**TOPOGRAPHIC SURVEY
SEASPECT SHORT PLAT
JOHN KAHAN**

NO.	DESCRIPTION	DATE
3	PERMIT REVISION	04.19.22
4	PERMIT REVISION 2	06.10.22
5	PERMIT REVISION 3	08.30.22

CLARKSON RESIDENCE
8163 W MERCER WAY
 City of Mercer Island, Washington

1 NORTH - SOUTH SECTION
3/16" = 1'-0"

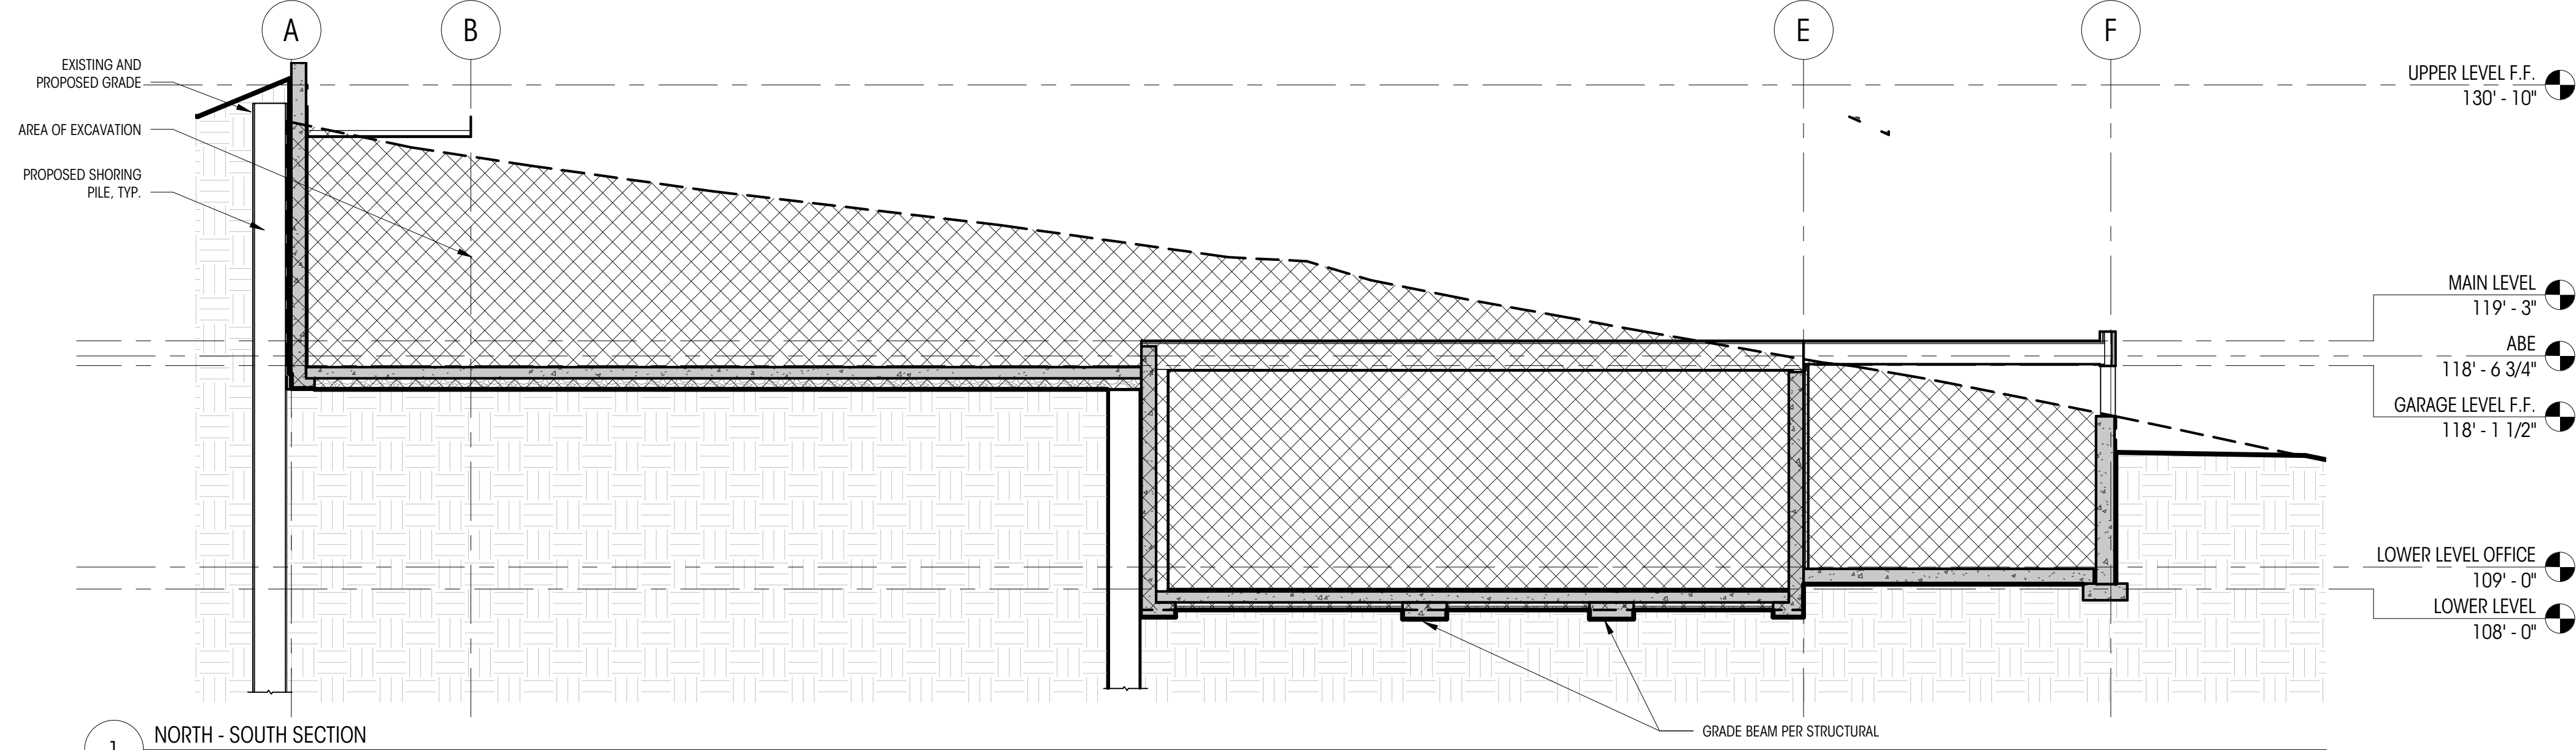
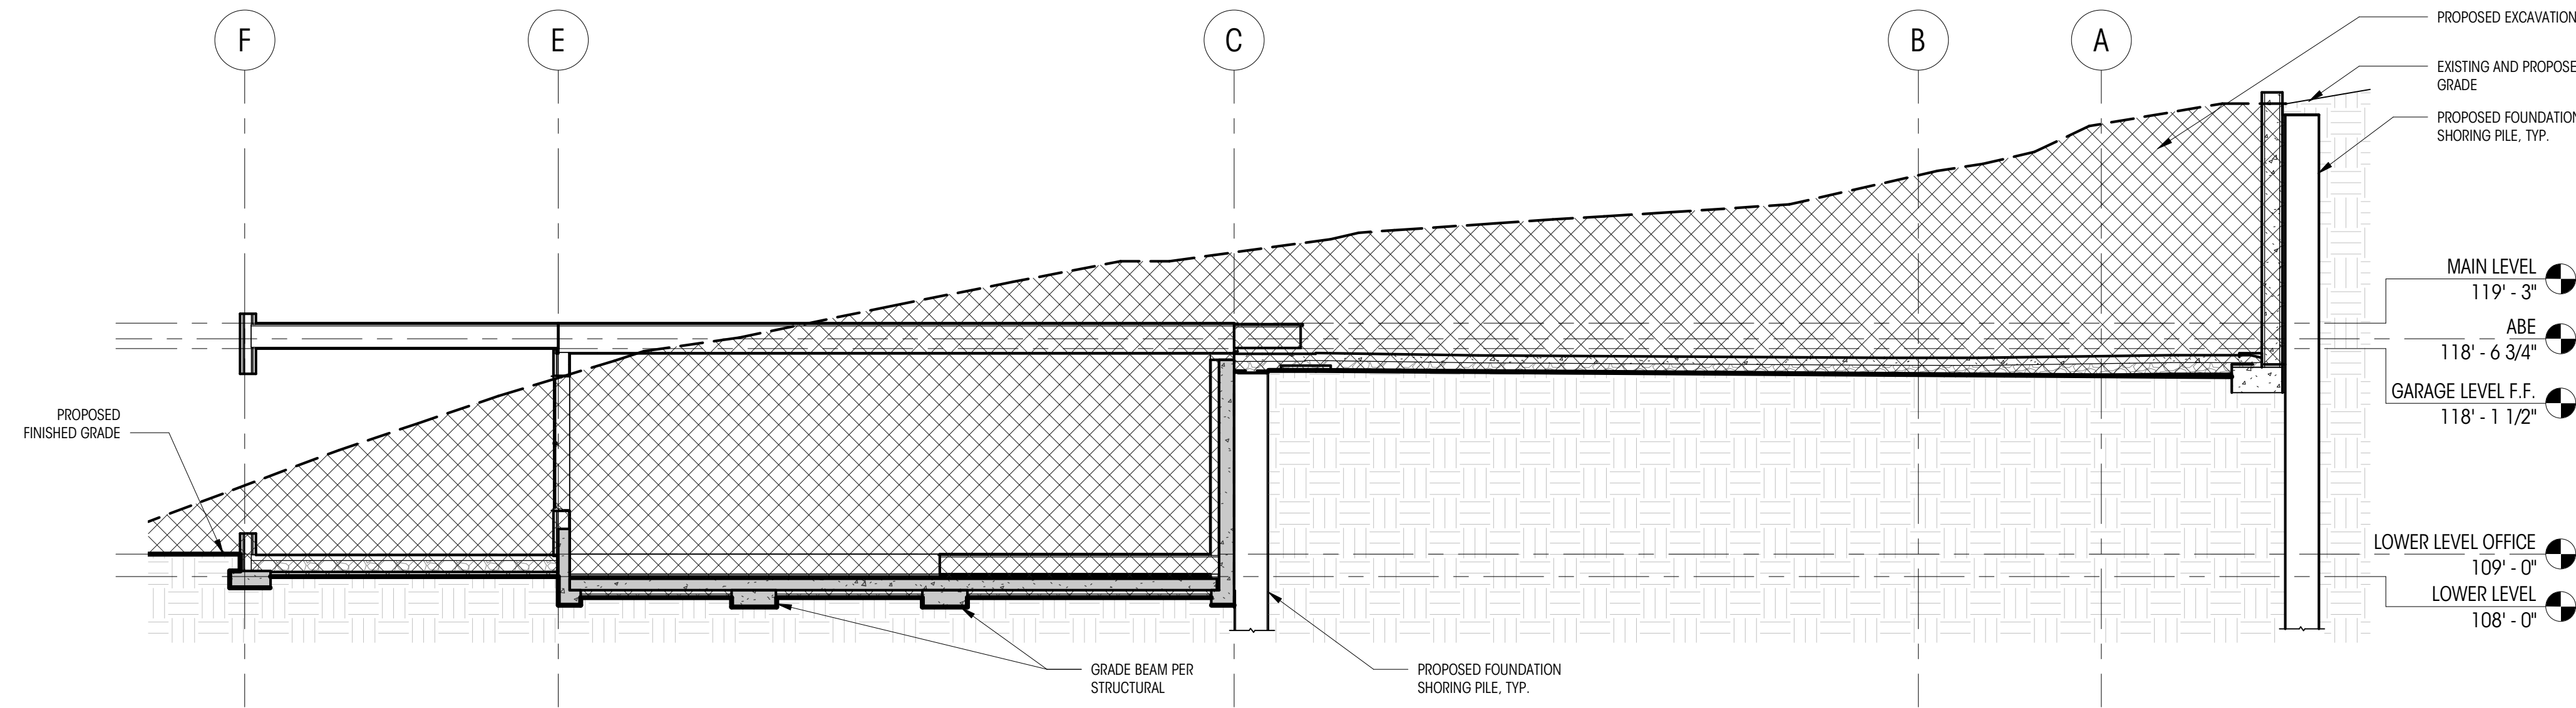
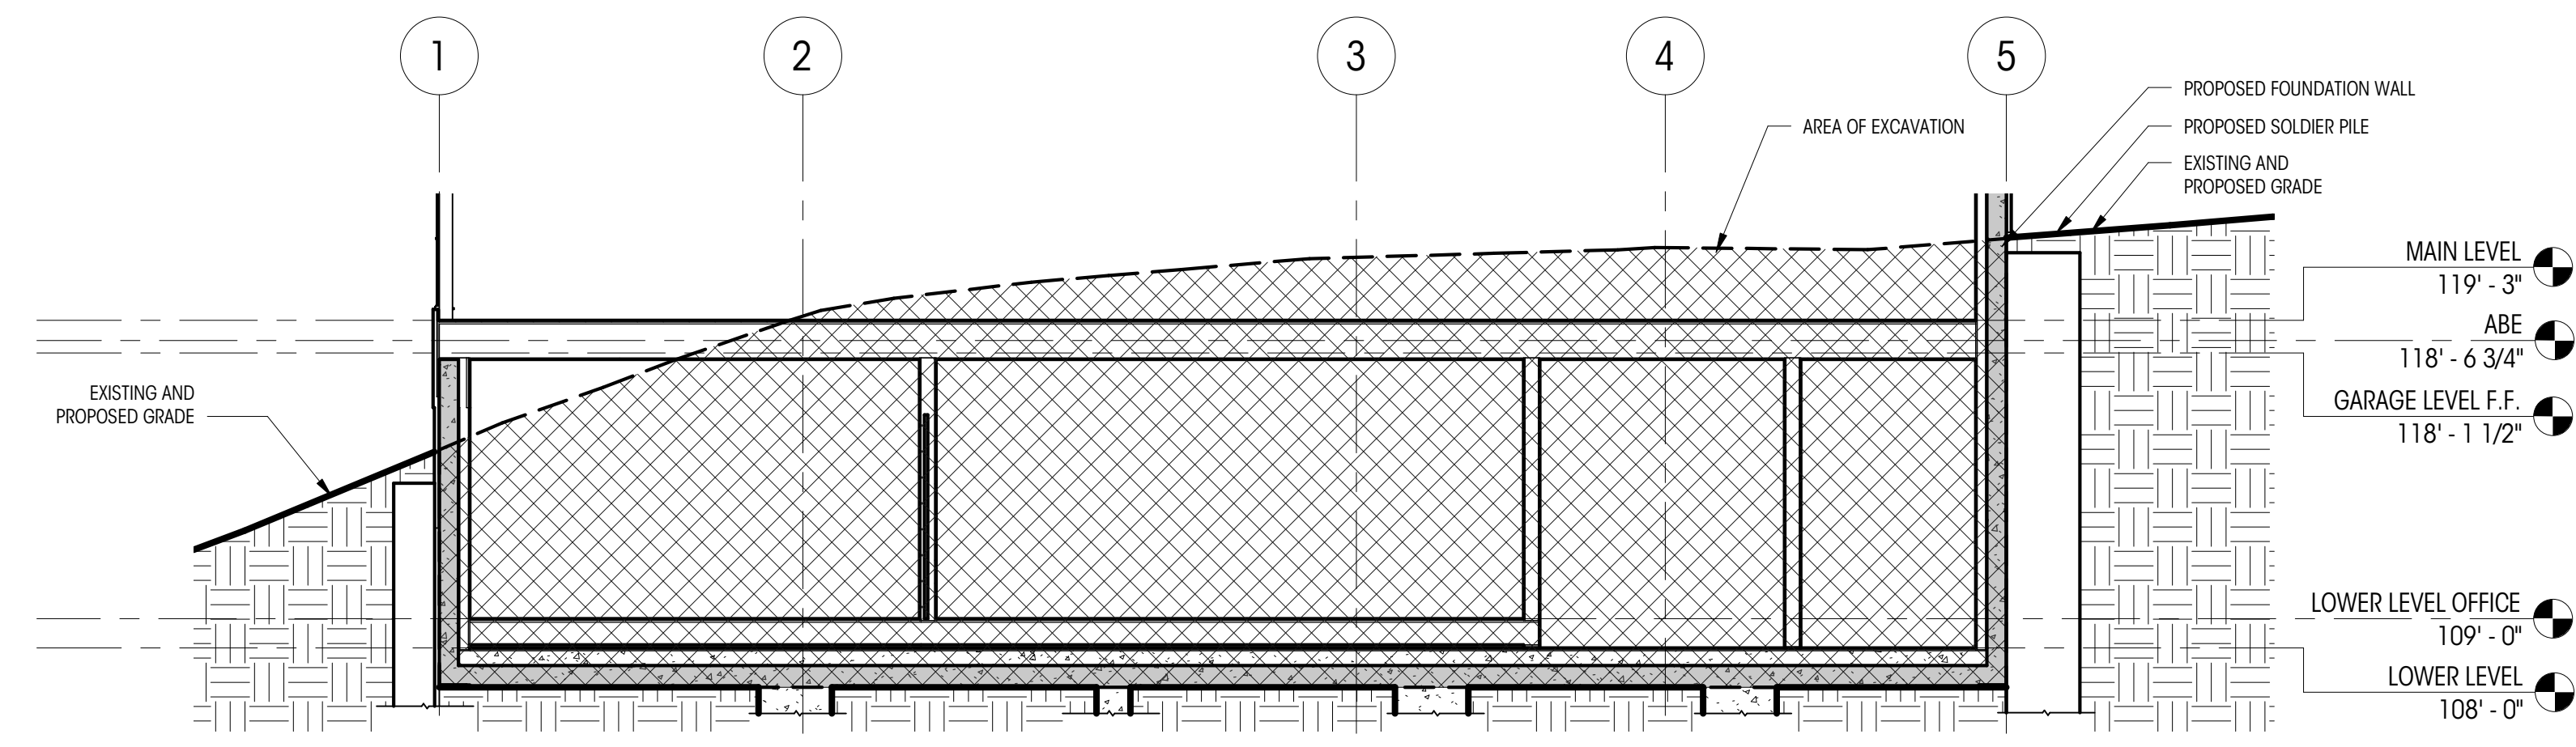
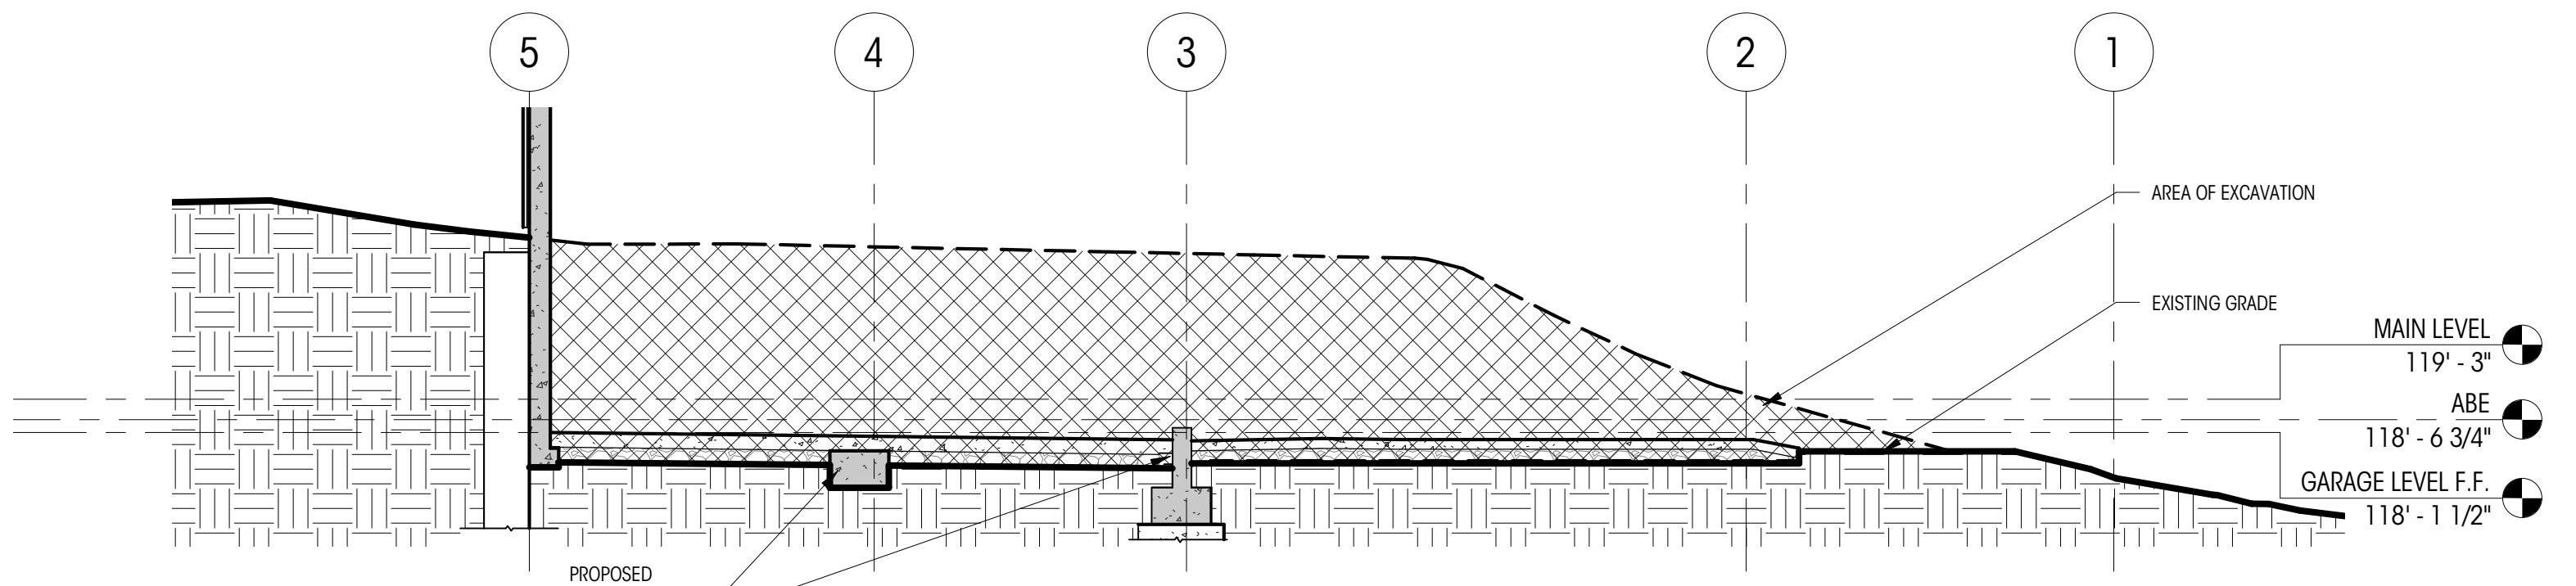
- LEVEL CHANGES: DRIVEWAY & GARAGE LEVEL DROP BY 15"; BASEMENT LEVEL DROP BY 12"
- CHANGE TO ABE AS A RESULT OF EXTENDED GARAGE AND EXTENDED COVERED DECK
- VIEW NUMBERING HAS BEEN UPDATED FOR CONSISTENCY

1 SITE SETBACK & BUILDING PAD PLAN
1" = 10'-0"

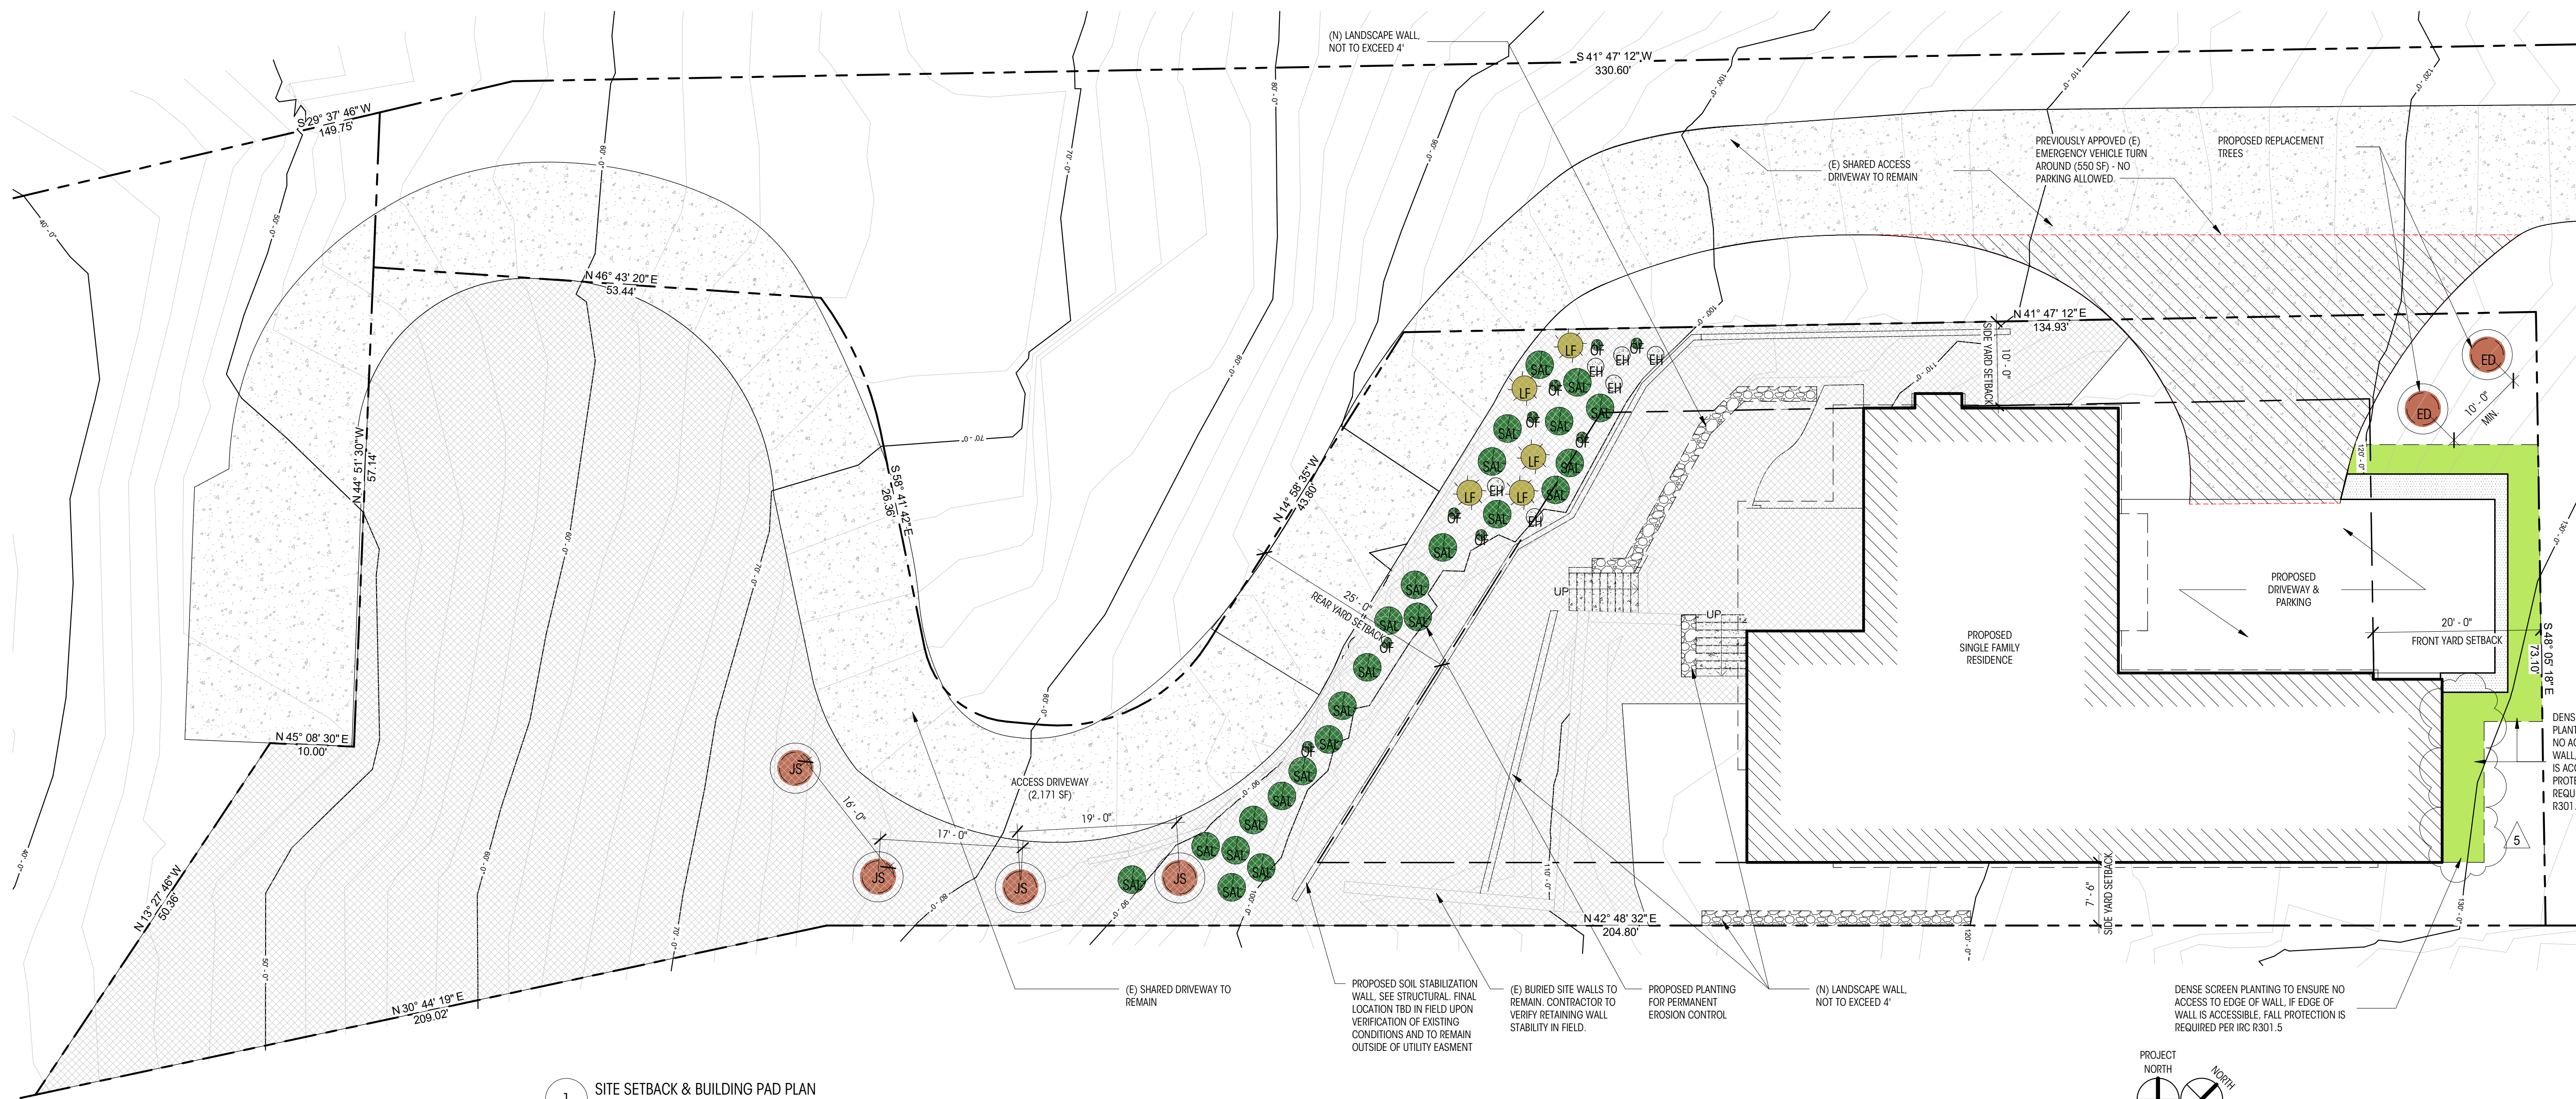
- REVISED LOCATION OF REPLACEMENT TREES
- SHIFT OF PARKING RETAINING WALLS TO NORTH AND SOUTH
- CHANGE IN SOIL RETENTION WALL: PREVIOUSLY AS PART OF THE FOUNDATION SYSTEM, NOW MOVED TO WESTERN YARD ADJACENT TO ROAD IN ORDER TO ALLOW FOR LANDSCAPE WORK
- REVISED FOUNDATION AS A RESULT OF SOIL STABILIZATION WALL LOCATION MOVE
- CHANGES TO HARDSCAPE CALCULATIONS AS A RESULT OF SOIL STABILIZATION WALL, PATIO EXTENSION AND SITE STAIRS
- GRAPHICS/PATTERNS/HATCHES HAVE BEEN COORDINATED FOR CONSISTENCY
